GRADING/PAVING PLAN
 THE FOLLOWING ITEMS CONCERNING (4610-A McLeod Rd. N.E.) TRACT E, SECO SUBDIVISION, BERNALILLO COUNTY, ALBUQUERQUE, NEW MEXICO ARE CONTAINED HEREON:
 EXISTING CONDITIONS
 AS SHOWN ON THE VCNITY MAP, THE SITE CONTAINS 0.5303 ACRES MORE OR LESS AND IS LOCATED SOUTH OF McLEOD RD. N.E. BETWEEN JEFFERSON ST. N.E. AND HARDWARE DRIVE N.E. THE SITE IS COMPLETELY DEVELOPED WITH A 9942 SQ. FT. BUILDING ALONG WITH ASSOCIATED ASPHALT PAVING AND LANDSCAPING. THE SITE DRAINS FROM EAST TO WEST. NO OFF-SITE FLOWS ENTER THE SITE FROM ANY DIRECTION. ACCORDING TO THE FLOOD INSURANCE RATE MAPS, PANEL 0139E, REVISED NOVEMBER 19, 2003, THIS SITE IS NOT LOCATED WITH A DESIGNATED FLOOD ZONE, NOR DOES IT CONTRIBUTE TO ANY DOWNSTREAM FLOODING.
 PROPOSED CONDITIONS
 AS SHOWN BY THE GRADING/PAVING PLAN, THE PROJECT WILL CONSIST OF THE REMOVAL AND REPLACEMENT OF ALL THE ASPHALT AREAS. A RETAINING WALL WILL BE CONSTRUCTED ON THE NORTH AND EAST PROPERTY LINES. THE EXISTING DOCK AREA WILL BE REMOVED. A CONCRETE VALLEY GUTTER WILL BE CONSTRUCTED SO AS TO CONVEY THE RUN-OFF FROM THE EAST AND NORTH. THE CALCULATIONS, WHICH APPEAR HEREON, ANALYZE THE EXISTING AND PROPOSED CONDITIONS FOR THE 100-YE

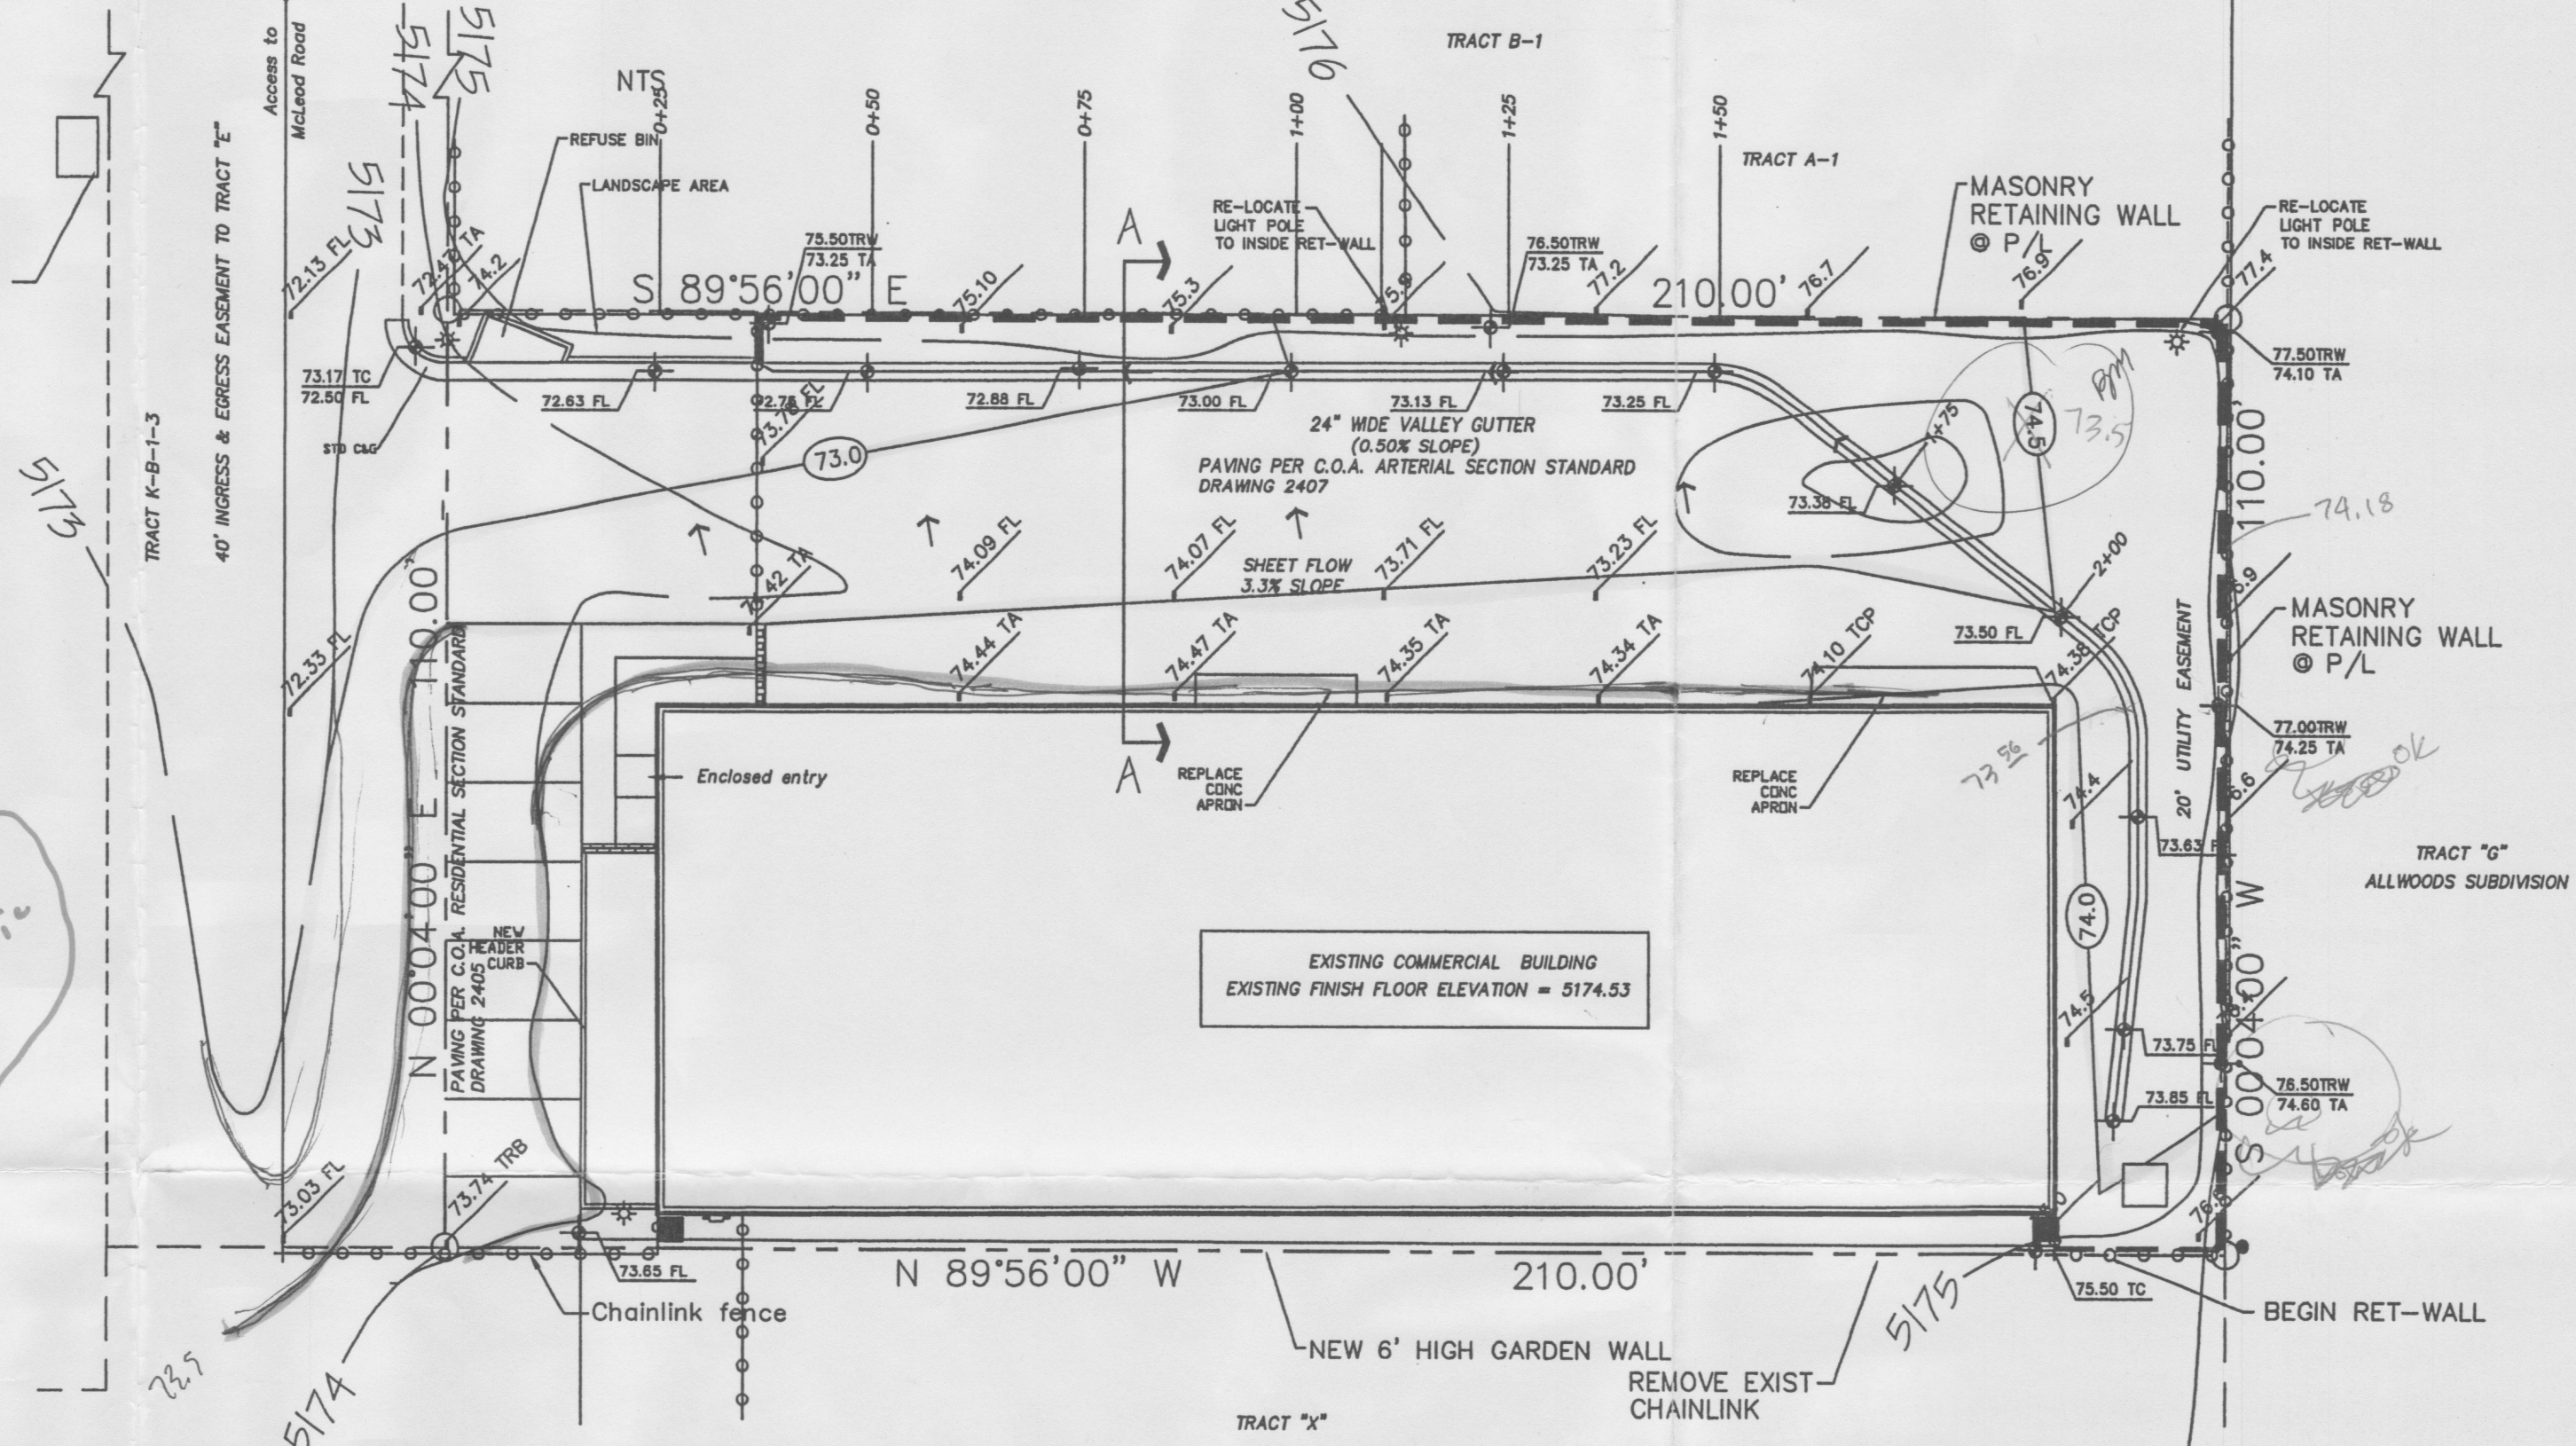
This doesn't look like the approved layout
